Amendments to the Drawings

FIG. 3

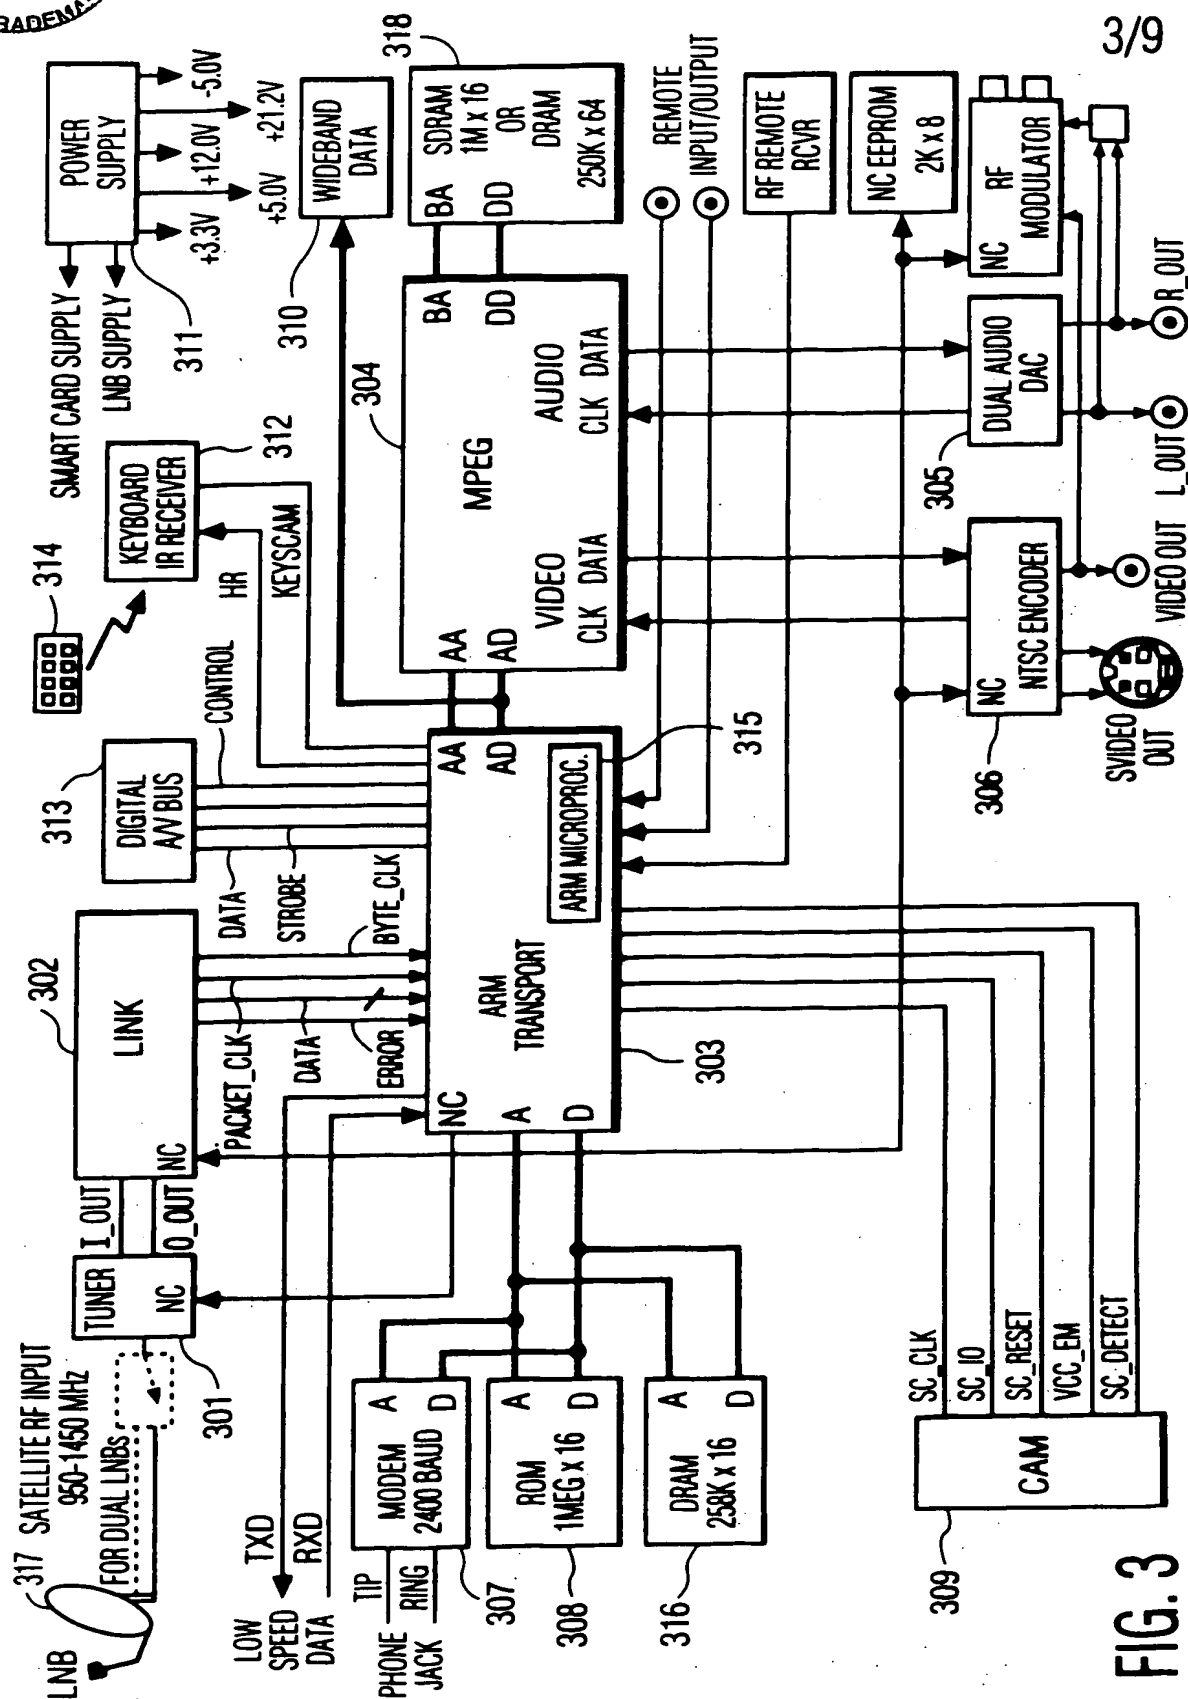
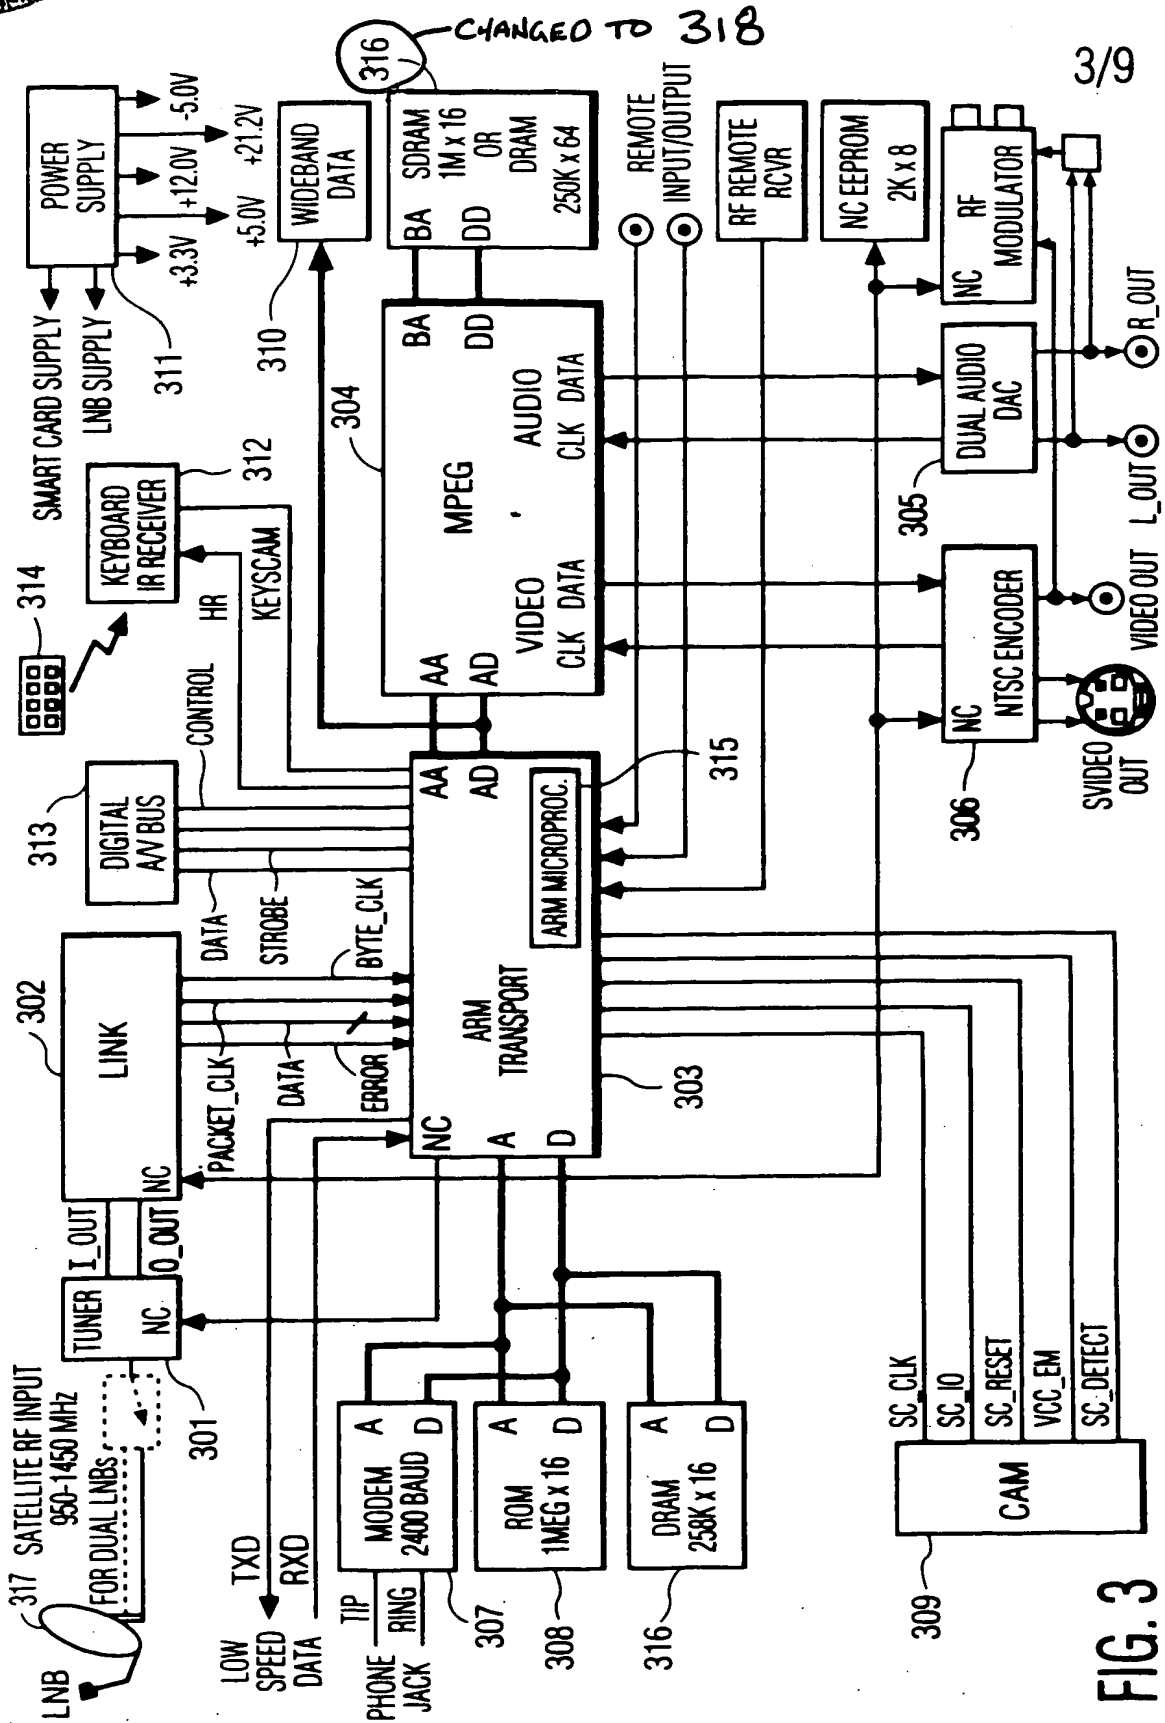
The attached sheet of drawings includes changes to Fig. 3. This sheet replaces the original sheet including Fig. 3. In the replacement Fig. 3, the label for the SDRAM has been changed from 316 to 318.
